ND-2013-0005
March 11, 2013

Subject: **PSEG Early Site Permit Application**
Docket No. 52-043
Response to Request for Additional Information, No. Env-09S,
ESP EIS 9.0 - Environmental Impacts of Alternatives

RESPONSE to RAI No. Env-09S

**QUESTION No.
ESP EIS 9.0-15 (ESP EIS 9.0-9S)**

Figure RAI ENV 9.0-9S-1

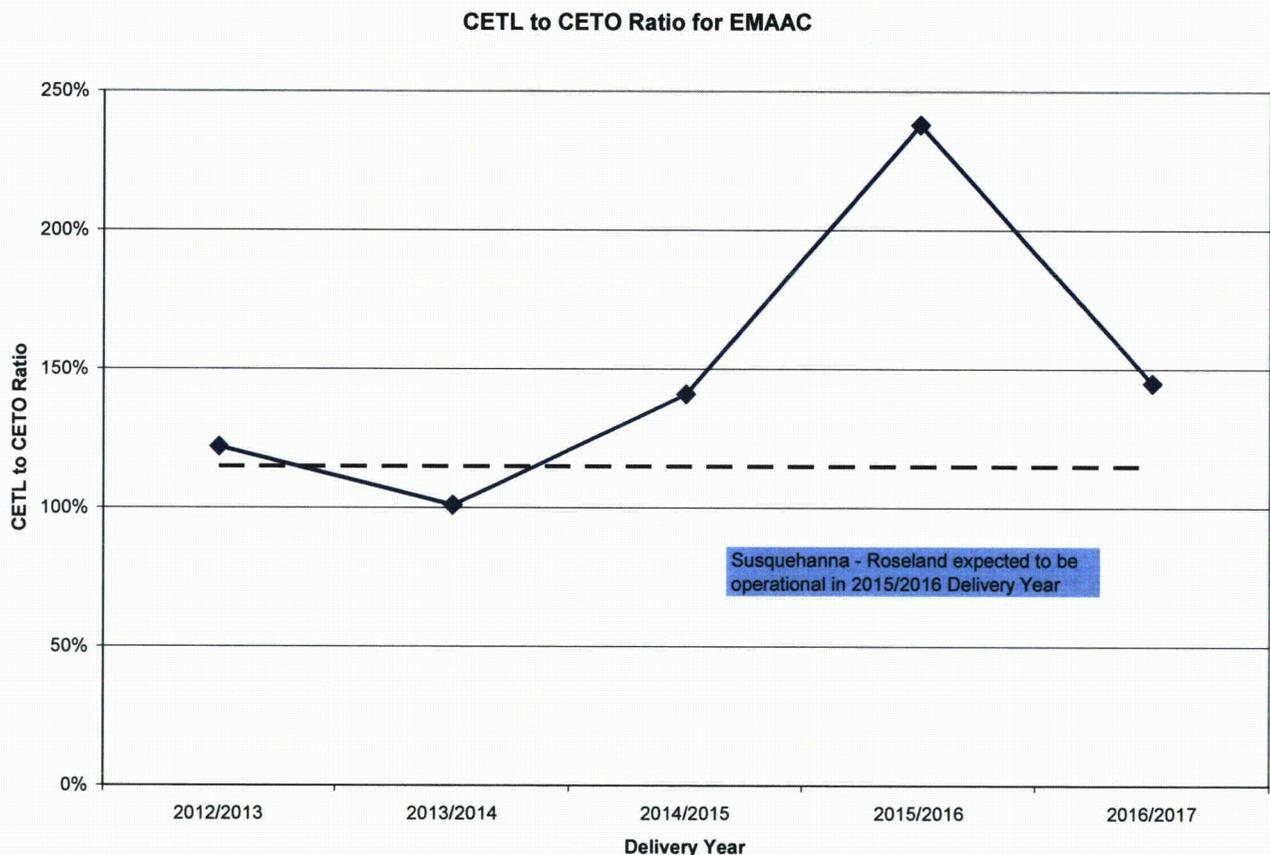
ESP EIS 9.0-9S: Explain whether importing power into New Jersey instead of generating it with new nuclear units at the PSEG ESP site is a feasible([1]) option. If it isn't a feasible option, provide an analysis that explains why not. If it is feasible, explain the basis for that conclusion and provide an analysis of the environmental impacts associated with importing power as an alternative to building new nuclear units at the proposed PSEG ESP site.

Provide an updated discussion as to whether or not imported power is a feasible alternative to the power that would be generated by new units at the PSEG ESP site. In discussing the feasibility of imported power include consideration of the availability of surplus power from areas near the PSEG region of interest.

The 2016/2017 RPM Base Residual Auction Planning Period Parameters shows that the CETL to CETO ratio for EMAAC is 145% (Reference RAI ESP EIS 9.0-15-3). Figure RAI ENV 9.0-9S-1 depicts the trend in the CETL to CETO Ratio for the 2016/2017 Delivery Year and the previous four Delivery Years.

The figure shows that import capability into EMAAC is constrained prior to the expected completion of various transmission enhancement projects, most notably the SR Project in 2015. These identified constraints justify the need for the transmission enhancement projects. Among the several transmission projects planned by PJM, the SR project provides the predominant amount of constraint relief in EMAAC. To accommodate delays in the completion of the SR project, PJM has implemented interim operational

contingencies that manage flow on constrained transmission facilities in real time operation and adjusts generation and implements Demand Side Response (DSR) as required to maintain grid reliability. As shown in the graph, the import capability into EMAAC in the 2015/2016 Delivery Year increases substantially following the planned completion of the SR project. However, the import capacity decreases in the following years as load increases and older fossil fueled units in New Jersey are retired.⁵
